To: Garrett Martin, Milestone Community Builders & Caitlin Admire, Norris Design
From: Louis Alcorn, Capital Metro Planning
Date: 9 November 2015
Subject: RESPONSE - Site Evaluation for Potential Future Bus Stop Placement (*The Grove at Shoal Creek*)

The Grove at Shoal Creek
Austin, Texas

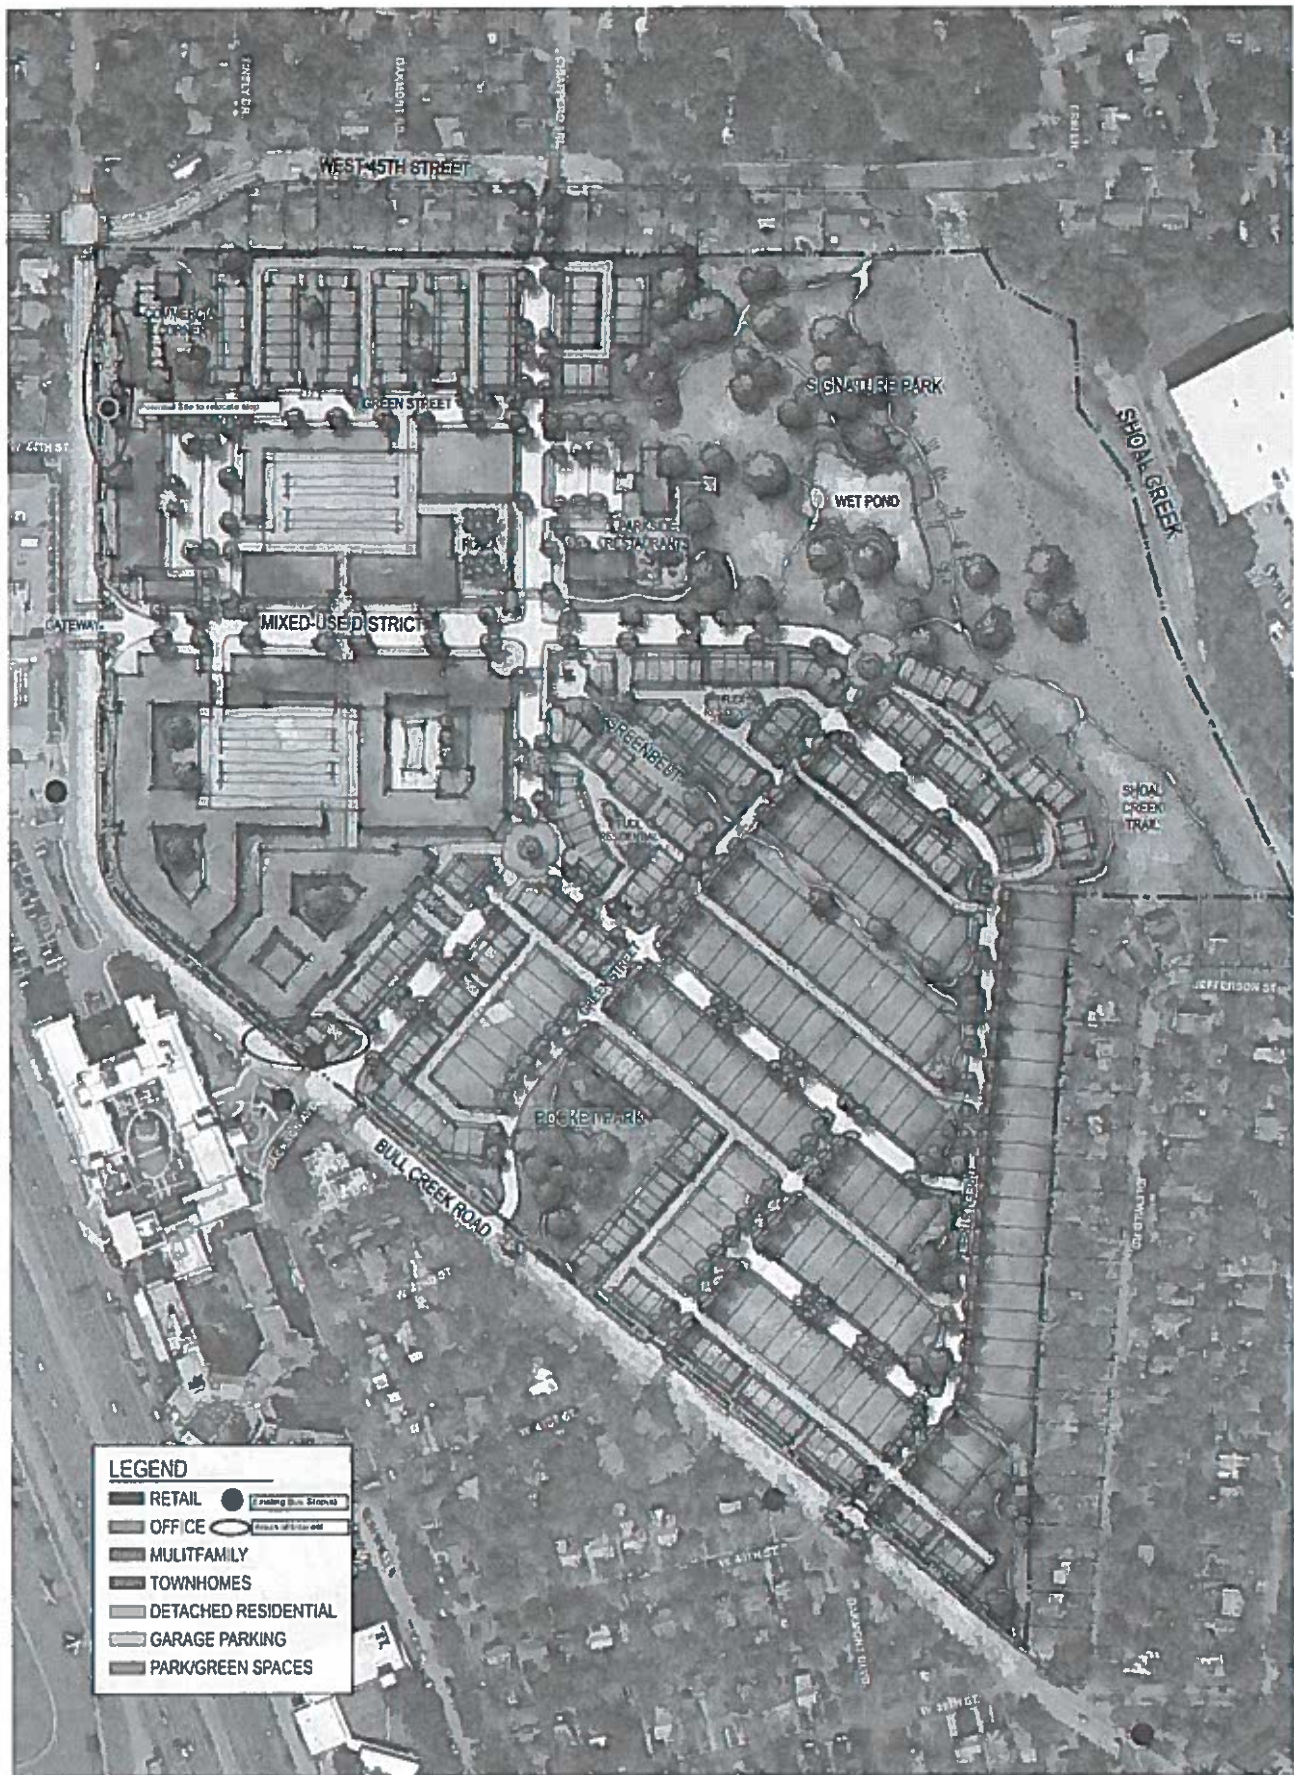
As per the Fall 2015 Update to our Service Guidelines and Standards, stop spacing in an area with medium density should generally be a minimum of 1,200 feet. This being said, the following map depicts our proposed bus stop placements, including the potential to relocate the W 45th & Bull Creek NB stop up to 300 feet south of its current location.

Bus stops should be approximately 25 feet in length by 10 feet in width and incorporated into the sidewalk. A larger area of approximately 15 feet in width (perpendicular to the road by 50 feet in length (parallel to the road) surrounding the stop should maintain a level slope to ensure that all ADA slope requirements are met.

What I have suggested here is based on what we know today and what is depicted in your site plan. We would want to continue to work with you as you develop your plans to help in refining these suggestions as you move forward.
